Well Name: CORRAL 23-35 FED COM	Well Location: T25S / R29E / SEC 23 / NWNW / 32.121693 / -103.962864	County or Parish/State: EDDY / NM
Well Number: 103H	Type of Well: OIL WELL	Allottee or Tribe Name:
Lease Number: NMNM120895	Unit or CA Name:	Unit or CA Number:
US Well Number: 3001556886	Operator: XTO ENERGY INCORPORATED

Notice of Intent

Type of Submission: Notice of Intent	Type of Action: APD Change
Date Sundry Submitted: 07/08/2025	Time Sundry Submitted: 02:41
Date proposed operation will begin: 07/15/2025

Procedure Description: XTO Energy Inc. respectfully requests approval to make the following changes to the approved APD. Changes include KOP, FTP, LTP, BHL, Proposed total depth, pool, and dedicated acreage, Formation, Casing Design, Cement Program & Mud Circulation System. APD ID 10400098915; Well API: 30-015-56886 FROM: TO: KOP: 392' FNL & 268' FWL OF SECTION 23-T25S-R29E 330' FNL & 990' FWL OF SECTION 23-T25S-R29E FTP: 100' FNL & 1070' FWL OF SECTION 23-T25S-R29E 330' FNL & 990' FWL OF SECTION 23-T25S-R29E LTP: 100' FSL & 1070' FWL OF SECTION 35-T25S-R29E 330' FSL & 990' FWL OF SECTION 35-T25S-R29E BHL: 50' FSL & 1070' FWL OF SECTION 35-T25S-R29E 50' FSL & 990' FWL OF SECT

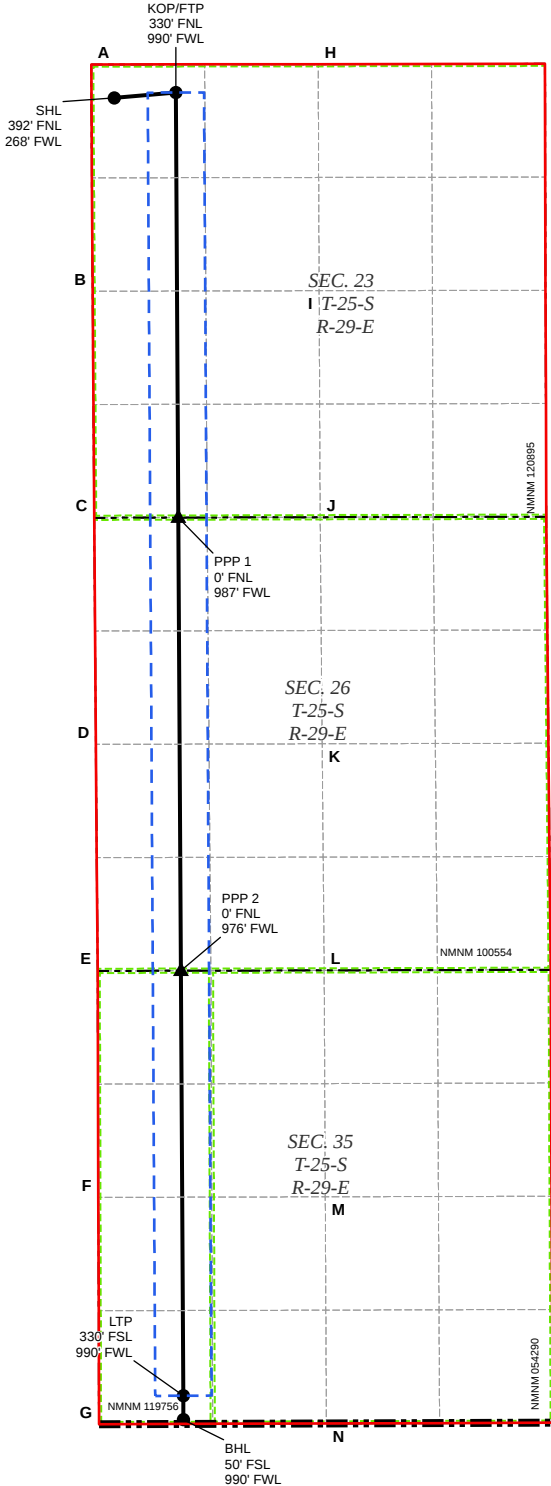
KOP: 392' FNL & 268' FWL OF SECTION 23-T25S-R29E 330' FNL & 990' FWL OF SECTION 23-T25S-R29E
FTP: 100' FNL & 1070' FWL OF SECTION 23-T25S-R29E 330' FNL & 990' FWL OF SECTION 23-T25S-R29E
LTP: 100' FSL & 1070' FWL OF SECTION 35-T25S-R29E 330' FSL & 990' FWL OF SECTION 35-T25S-R29E
BHL: 50' FSL & 1070' FWL OF SECTION 35-T25S-R29E 50' FSL & 990' FWL OF SECTION 35-T25S-R29E

The proposed total depth is changing from 25895 MD; 9467 TVD to 25625 MD; 10321 TVD.
Continued on page 3 additional information

The pool is changing from WILLOW LAKE; BONE SPRING, SOUTHEAST to PURPLE SAGE; WOLFCAMP (GAS).

The Dedicated acreage is changing from 640.00 to 1920.00.

OFFLINE CEMENTING

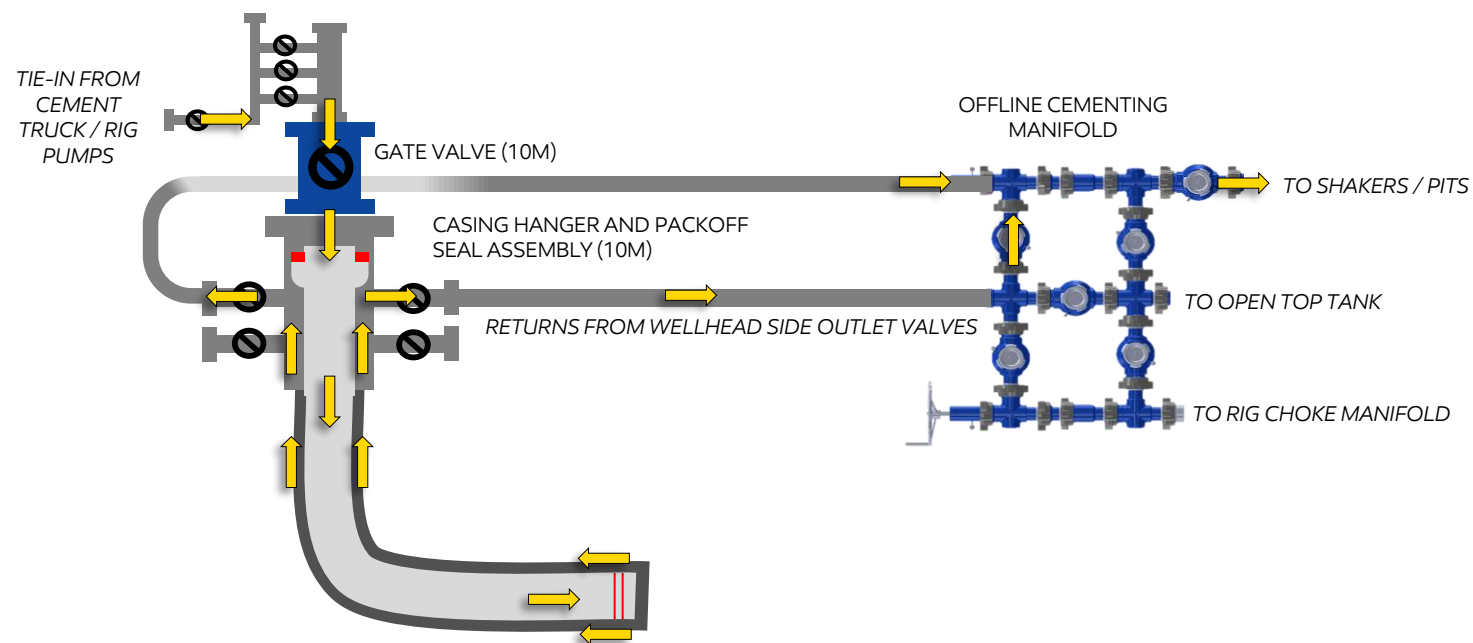
1. Rig BOP replaced by gate valve and WH adaptor assembly (10M rated)
2. Addition of offline cementing manifold and high pressure iron to direct fluid returns to rig active system and/or choke manifold
3. Packoff annulus barrier in place and tested prior to cementing operations (10M rated)
4. Cement truck performs cement job displacement (vs rig pumps)
